Providence City Plan Commission

AGENDA ITEM 3 ■ 279 THAYER STREET

OWNER/ APPLICANT:	Two Cousins LLC c/o Michael Boutros, Owner and applicant	PROJECT DESCRIPTION:	Major change to an approved plan to add a fifth story and four dwelling units to a mixed use development approved for four stories with 12 units. The applicant is requesting a dimensional adjustment for height.
CASE NO./ PROJECT TYPE:	24-049 MA Major Change	RECOMMENDATION:	Approval of the change subject to the noted findings
PROJECT LOCATION:	279 Thayer Street C-2 zoning district, I-3E overlay AP 13 Lot 28	PROJECT PLANNER:	Choyon Manjrekar
NEIGHBORHOOD:	College Hill

Building elevation and rendering

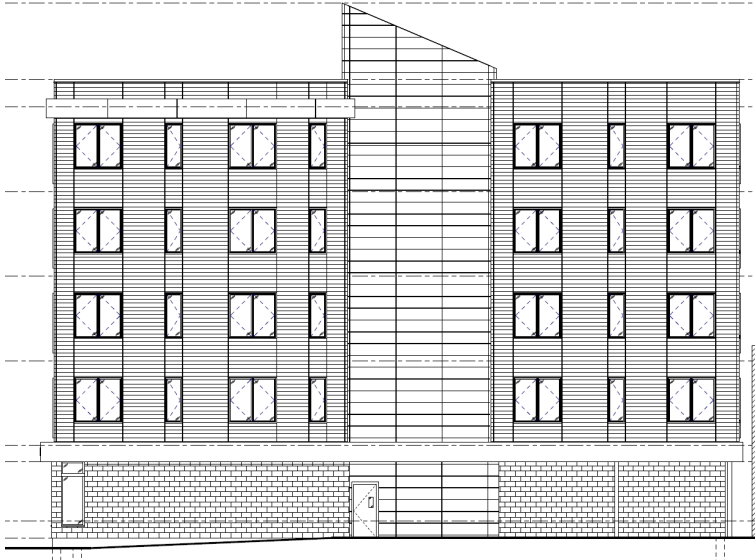
A height of 55’ and four stories is proposed with the addition, for which an adjustment has been requested. Over 60% of the front façade will be located at the front lot line, meeting the design requirement of the C-2 zone. Residents will enter from a recessed entry on the northern portion of the building. The entrance to the commercial area will exceed the 50% transparency requirement at street level. A dining area will be located between two retail spaces.

The trash pickup area will be located at the rear of the southern portion of the building. The upper stories will be treated with fiber cement paneling with a lighting strip shaped like an inverted ‘L’ running on the side and parallel to the roof line, providing variety to the façade. The building’s design and materials conform to the design requirements of the C-2 zone with no design waivers required.
